Access Compliance Report

Public Rights-of-Way

(Curb Ramps)

Intersection ID: 12279	Main Street: S_MINT_ST	Cross Street: W_MARTIN_LUTHER_KING_JR_BV	Location: W
ADA ID: CB1B72B27B02	Ramp Type: PerpDiag	Initial Pass/Fail: Fail	Overall Compliance: No
Severity Score: 33.75			
Codes/Mitigation Info/Possible Solution		Field Measurements/Component Compliance

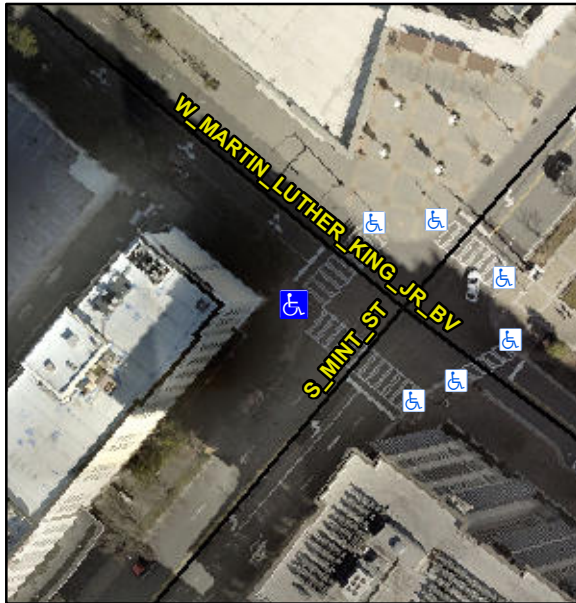
Not Found, R304.5.1, R304.2.2, R304.5.3

Compliance	Description	Data	Compliance	Description	Data
N/A	Ramp Length (in)	73.0	No	Ramp Slope (%)	9.8
No	Ramp Width (in)	44.0	No	Ramp XSlope (%)	5.2
N/A	Flare Type LT	N/A	N/A	Flare Type RT	N/A
N/A	Flare Slope LT (%)	N/A	N/A	Flare Slope RT (%)	N/A
N/A	Flare Traversable LT?	N/A	N/A	Flare Traversable RT?	N/A
N/A	Landing Length (in)	N/A	N/A	DWS Provided?	N/A
N/A	Landing Width (in)	N/A	N/A	DWS Contrast?	N/A
N/A	Landing Slope (%)	N/A	N/A	DWS Length (in)	N/A
N/A	Landing X Slope (%)	N/A	N/A	DWS Full Width?	N/A
N/A	Landing Curb? (Y/N)	N/A	N/A	DWS Offset (in)	N/A
N/A	Shared Landing?	N/A			
N/A	Gutter Ponding?	N/A	N/A	Gutter Slope (%)	N/A
N/A	Gutter Lip Ht (in)	N/A	N/A	Gutter X Slope (%)	N/A
N/A	Painted X Walk1?	Yes	N/A	Painted X Walk2?	Yes
	X Walk 1 Direction	To SE		X Walk 2 Direction	To NE
N/A	X Walk 1 Width (in)	171.0	N/A	X Walk 2 Width (in)	170.0
	X Walk 1 Slope (%)	2.7		X Walk 2 Slope (%)	2.0
	X Walk 1 X Slope (%)	3.7		X Walk 2 X Slope (%)	2.6

Remove & Replace Curb Ramp With Two New Directional Ramps or Equivalent.
